RE: COFA Submittal #3 – Big Blue Marble Academy Cypress Ridge

RE: Big Blue Marble Cypress Ridge – Planning Commission Comment Responses

BIG BLUE MARBLE ACADEMY

A 312

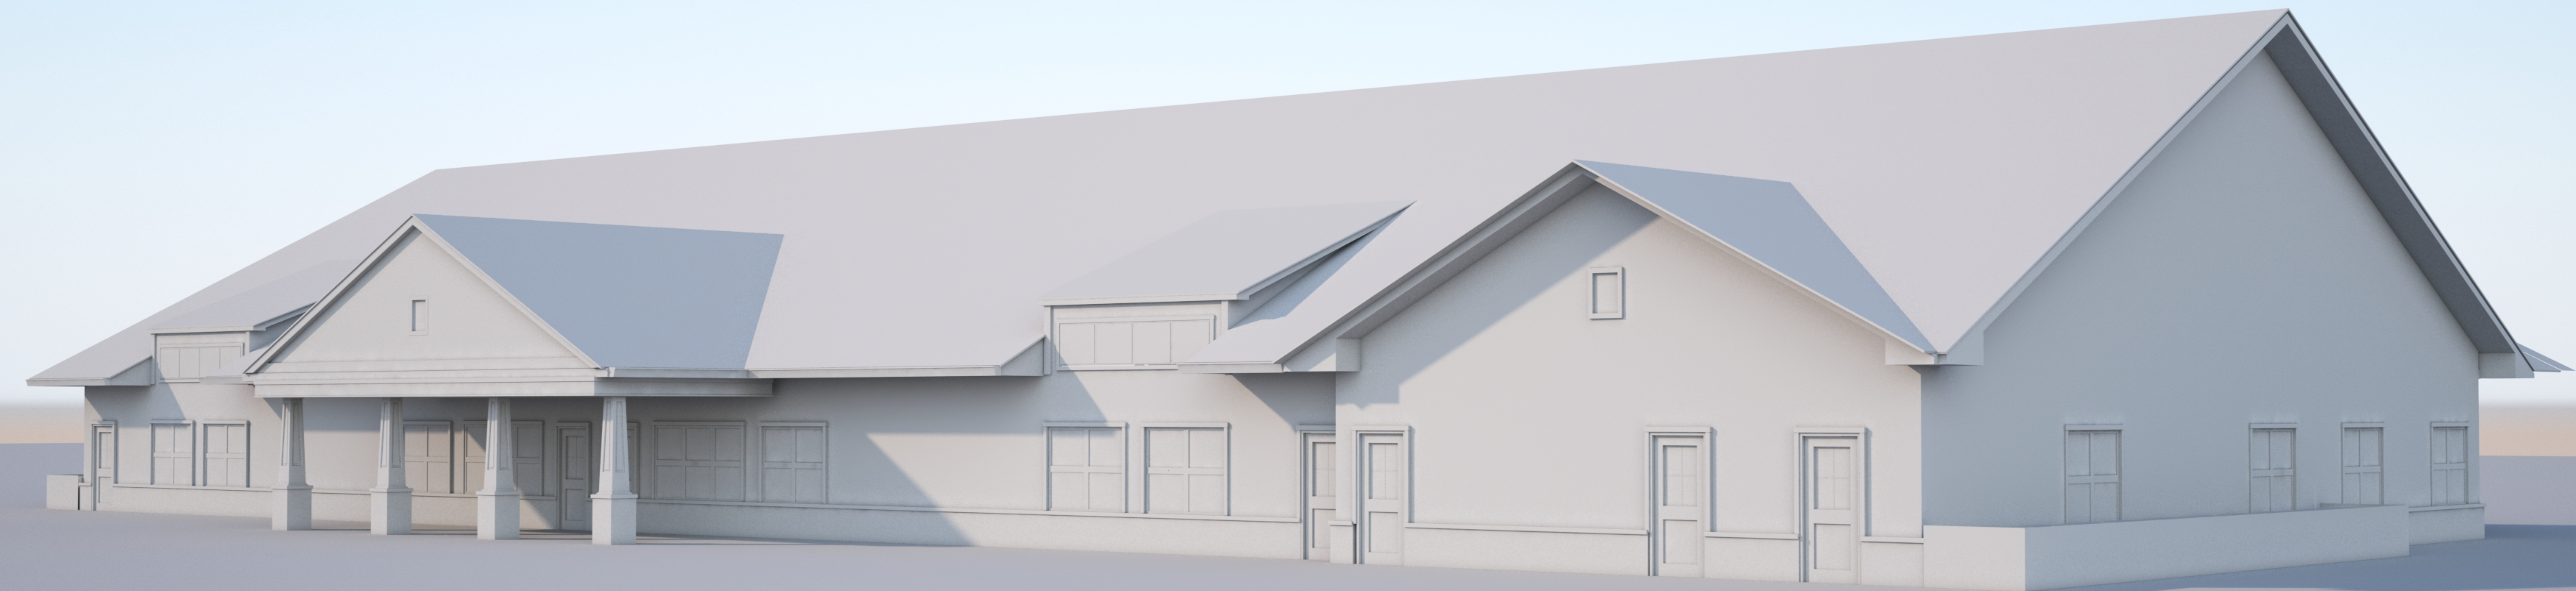
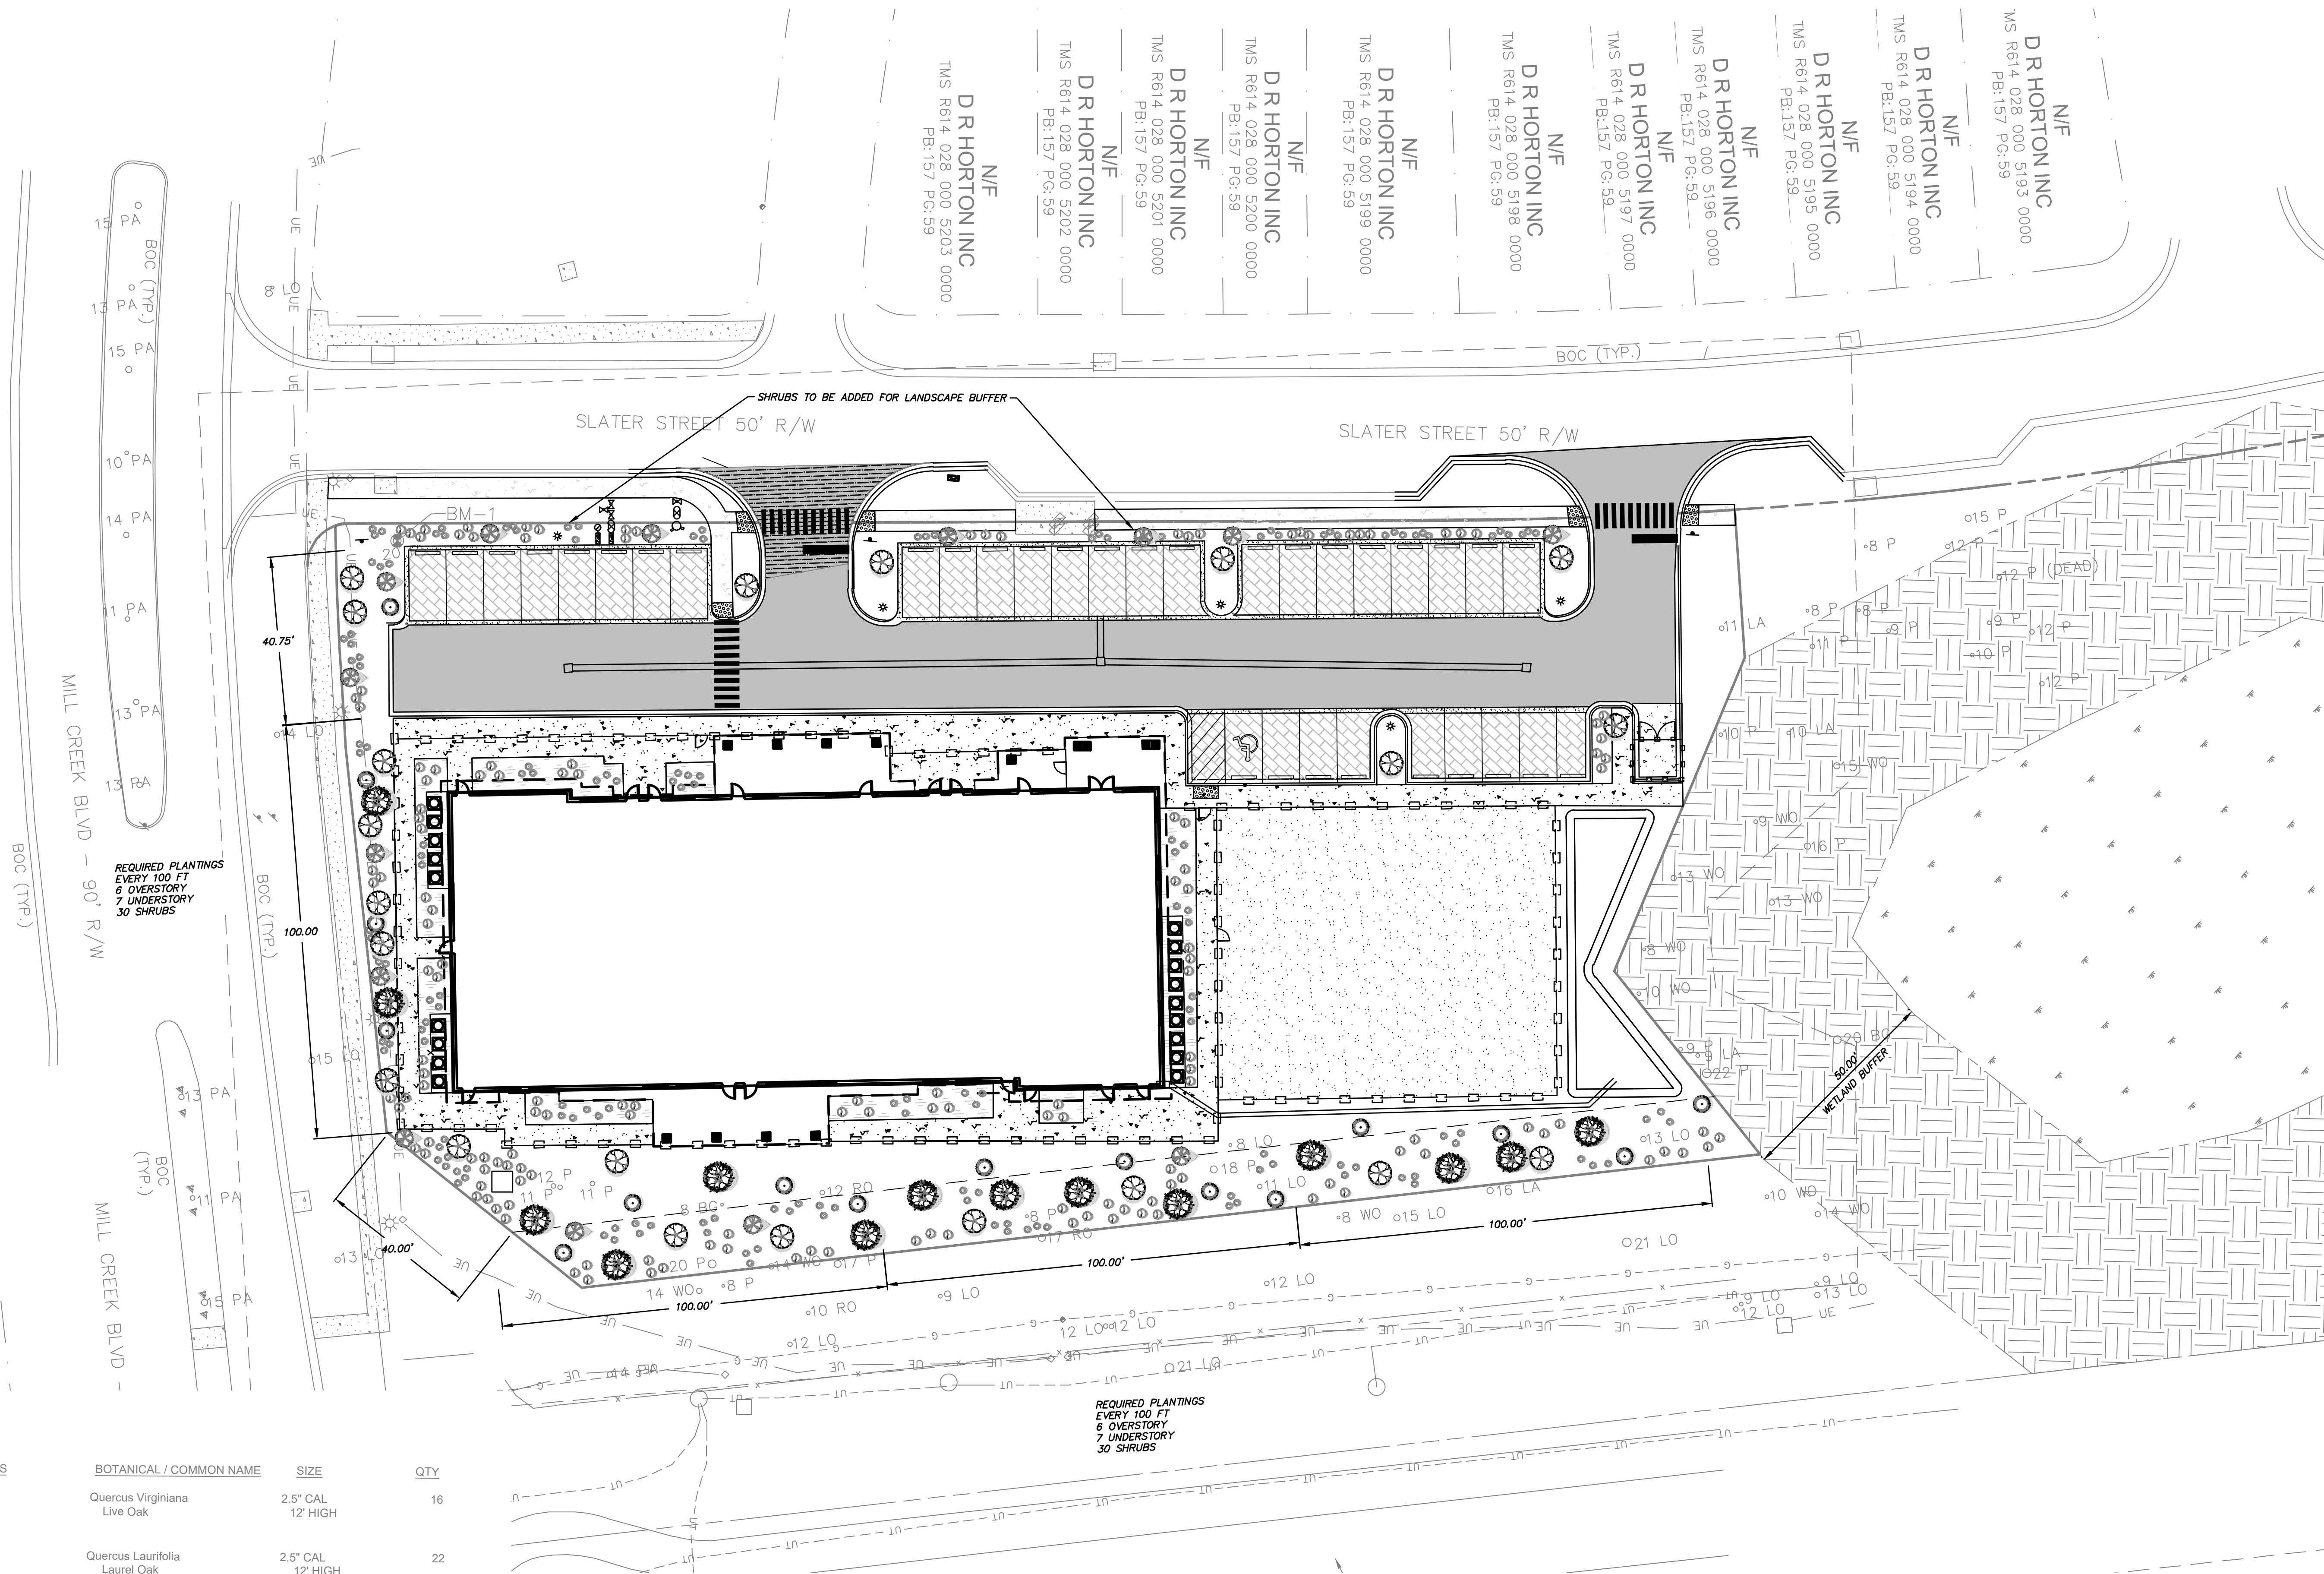
- Electric meter relocated to the east elevation and fully screened from view within the mechanical unit fencing.
- c. Per Section 4.24.3.A.3. of the ZDSO the dumpster enclosure must be revised from unfinished Split Face CMU to a permitted material.

- Dumpster enclosure revised to Savannah Grey brick to match building exterior.
- d. The Applicant should consider revising the pedestrian door operation on the dumpster enclosure to minimize conflict with pedestrians entering from the building. (switching the hinges so they don't have to walk around the door they just opened)

- The side door has been removed and now has front gate access instead.
- e. Information on the proposed metal fence must be provided for review as not enough information has been to complete the review. When you provide the fence detail – also ensure gate locations are shown on the landscape/site plan
